# Review DIAVIK Version 4 Closure and Reclamation Plan

FINAL REPORT TO  
ENVIRONMENTAL MONITORING AND ADVISORY BOARD  
AUGUST 2017

By Randy Knapp

Figure from Diavik 2011 ICRP.

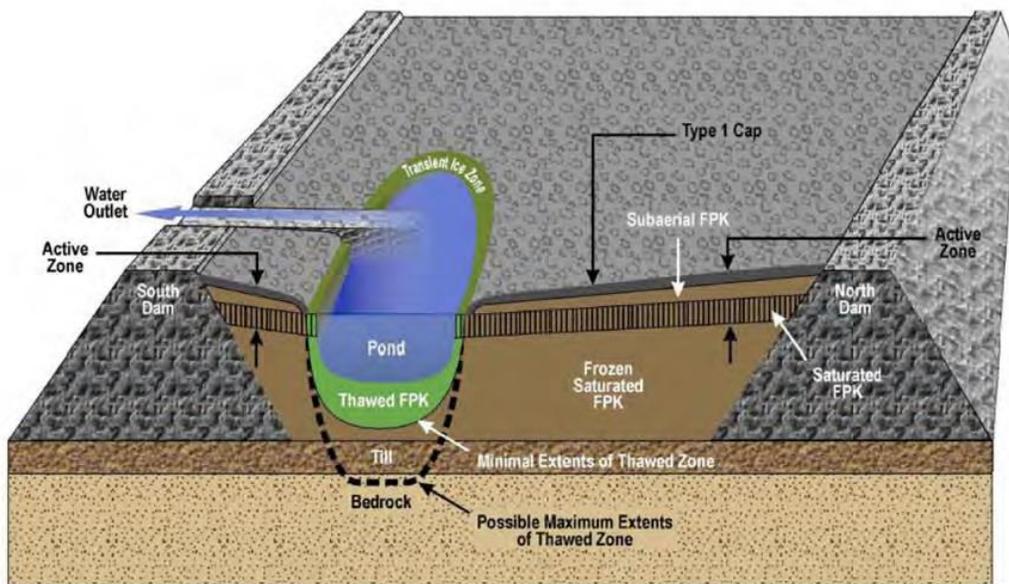
The proposed closure design for the Processed Kimberlite Containment is provided in Appendix X-5 of the Version 4 ICRP. The concept for the design was revised and included in 2011 ICRP. AMEC in their report (Diavik Diamond Mine PKC Facility Revised Closure Concept-28 November 2013) provided additional review and details on the design and made suggestions for minor revisions. AMEC concluded the original concept of creating a domed cap over the PKC was not constructible and concluded the revised plan was constructible and should meet closure objectives. The revised design, approved by the Water Board, includes a concave surface sloping down to a central pond which has a drainage ditch with an overflow spillway to Lac de Gras. The surface is to be covered with 2 m of waste rock. The waste rock will extend into the pond.

What is clear from the work is the concept may be valid, however there is a high degree of uncertainty. The uncertainties are raised by AMEC and acknowledged by Diavik.

There is a substantial degree of uncertainty with regard to the quantity of seepage that will occur in the long term. When conducting the geochemical predictions of pond and seepage water quality, 2 scenarios were considered: one where 100 % of the net precipitation occurs as seepage, and a second where 50% of the net precipitation occurs as seepage. However, when the water balance modelling was completed to assess the impact of wet and dry periods, zero seepage was assumed.

The quantity of seepage is critical because it will determine how much water is stored in the pond and whether or not a pond can be maintained. AMEC indicated in 2013 that the current seepage rates are in the order of about 40 L/s. This level of seepage would not allow a permanent pond to form and would expose the fine PK. Seepage levels are anticipated to decline as freezing progresses. If seepage occurs in future, it is likely there will be conditions (drought) when the pond levels will drop with the potential to expose the fine PK. This exposure represents a potential hazard.

Seepage quality predictions are based upon the assumption that metals are formed from the oxidation of sulphide minerals in the PK and the amount of oxidation is based upon the depth of unsaturated/unfrozen PK. AMEC assumed that the active layer for oxidation was .25 to 1 m deep. Golder (Appendix B -Thermal and seepage Analysis) states on page 12 “With the rockfill cover in place, the active layer depth after 100 years in the FPK beach area is estimated to be 2 to 2.2 m for the scenario without the climate change effect; and 3 to 5 m for the scenario with the climate change effect. This suggests that the potential unfrozen zone would be 1-3 m deep as compared with the AMEC assumption of .25 to 1 m. This would greatly increase the amount of PK exposed to oxidation.

Other assumptions include porosity which was set at 0.3 (note this is not typical). One would expect a porosity of closer to .5 for consolidated coarse tailings. Golder in Table 3 of Appendix B show porosity of .44 for coarse PK and 0.6 to 0.75 for fine PK.

This is a simplistic model with highly uncertain inputs some of which are likely invalid and as such the predictions are highly suspect.
